Subject: BAR Action 315 W Main Street Oct 21, 2014

RE: Certificate of Appropriateness Application
BAR 14-10-08
315 West Main Street
Tax Parcel 320198000
The Inn at Vinegar Hill, LLC, Owner/ Expedite the Diehl, Applicant
Mariott Residence Inn signage (Comprehensive signage plan)

CITY OF CHARLOTTESVILLE BOARD OF ARCHITECTURAL REVIEW STAFF REPORT October 21, 2014

BAR 14-10-08
315 West Main Street
Tax Parcel 320198000
The Inn at Vinegar Hill, LLC, Owner/ Expedite the Diehl, Applicant Mariott Residence Inn signage (Comprehensive signage plan)

INTERNALLY ILLUMINATED BOX CANOPY SIGN ROUTED AND WITH PUSH THRU GRAPHICS

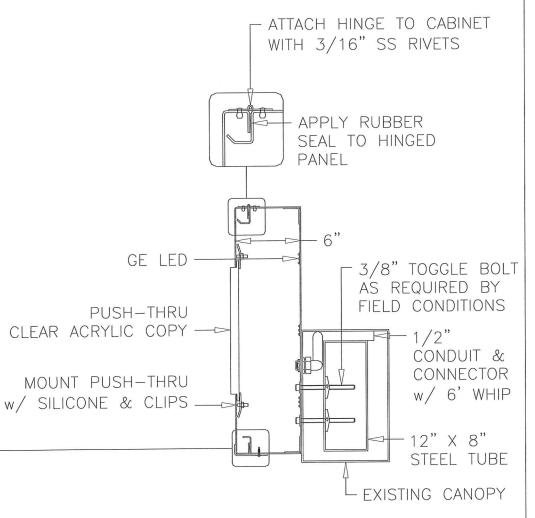
For the canopy signs, is the box opaque and the letters are the only things that glow?

- Yes, the canopy signs will have opaque backgrounds so that the copy is the only thing that lights at night.
- The current design for the directionals is so that the entire face portion of the sign illuminates. However, if needed, opaque vinyl can be added to the faces so that only the copy lights at night.
- The base of the directionals will have aluminum cladding.

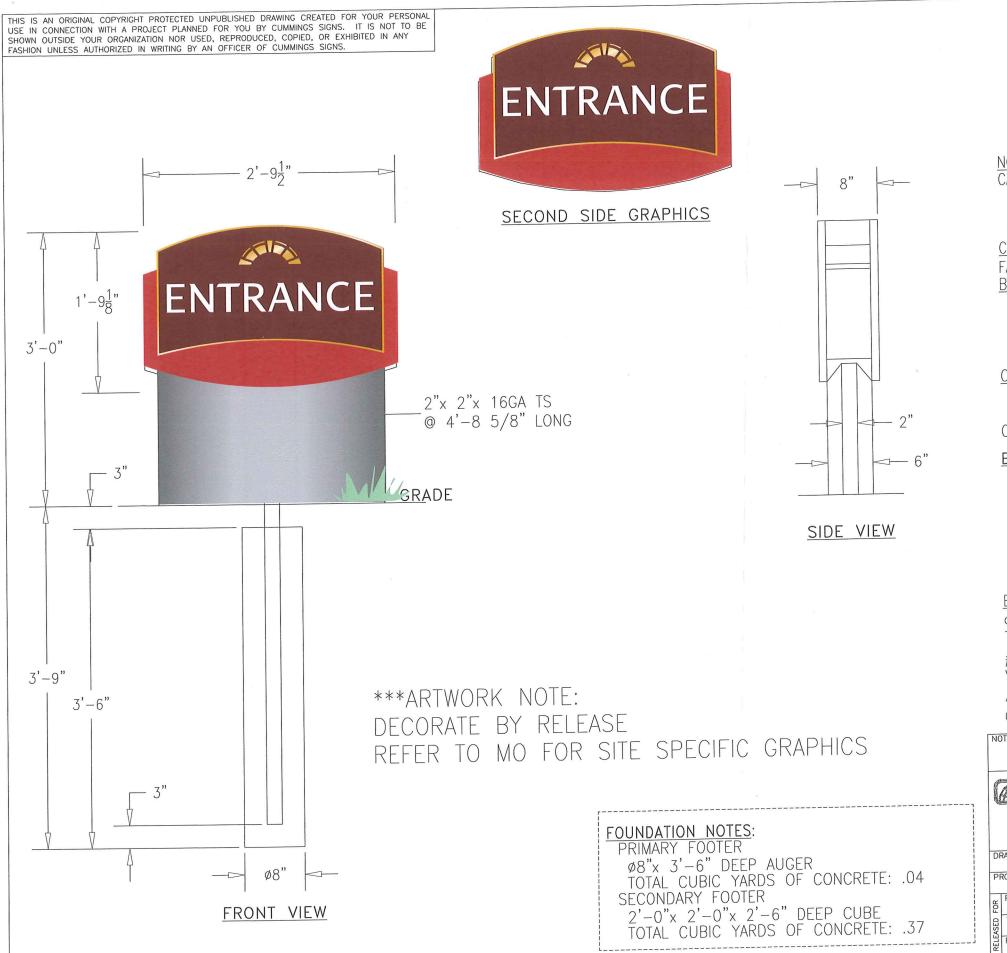
The BAR approved (7-0) the application as submitted (two canopy signs and a flag sign), except the two directional signs [in order to not require a comprehensive sign permit] shall have opaque backgrounds so that only the text "Entrance" is illuminated at night.

I need to know if the directional signs are intended to be only externally lit? It is not clear from your drawings.

The staff report says the letters on the directional signs will be the only parts lit, but the application makes it look like the entire sign glows. Is that a change from the application? Also, am I right in thinking the base of the sign will be acrylic?
